March 30, 1988

Mr. Charles MacDonald, Chief  
Transportation Certification Branch  
Division of Fuel Cycle and Material Safety, NMSS  
U.S. Nuclear Regulatory Commission  
Washington, D.C. 20555

I am providing the additional information requested for certificate of compliance number 9147 issued for the model 850 source changer. Enclosed please find revised drawings and pages to be inserted into the original Safety Analysis report submitted in October 1980.

MODEL 850 SOURCE CASING  
DESCRIPTIVE ASSEMBLY

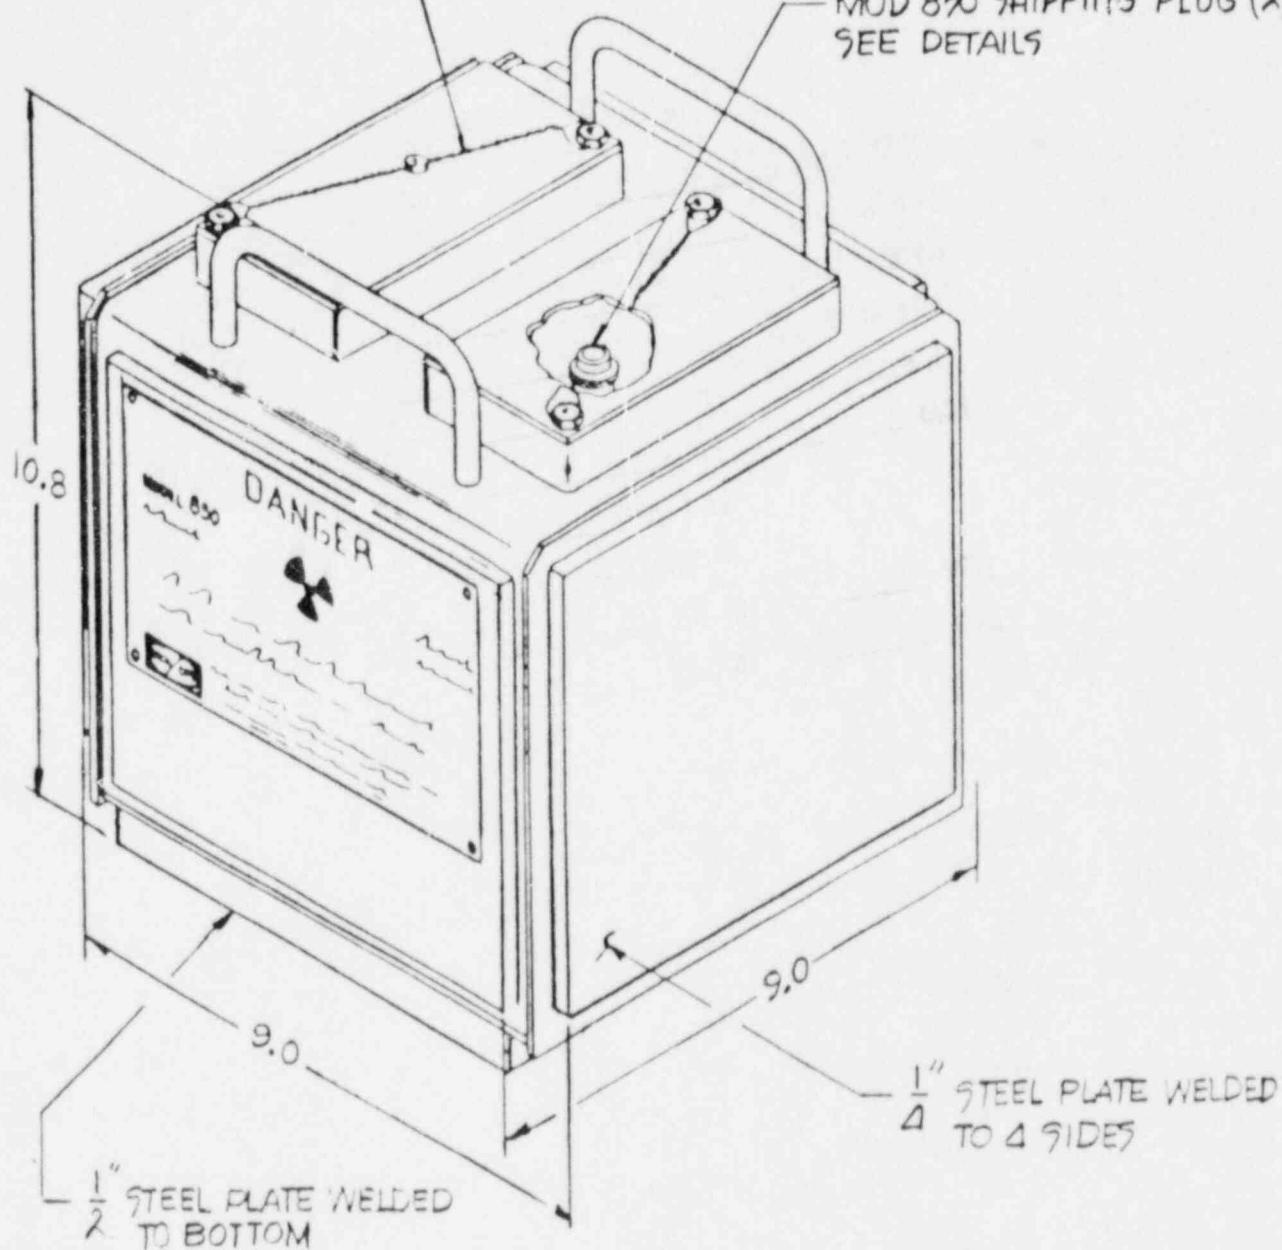
These revised drawings and pages answer most of the concerns noted in your letter dated 24 March 1987. In addition, to assure that the shielding plates are welded securely they undergo a visual inspection performed by Quality Control. Quality Control assures the welds are in accordance with the drawing. Visual inspection of the welds of Type B containers has been used for the past twenty-five years, in that time there has not been a weld failure in either transportation or field use of the containers.
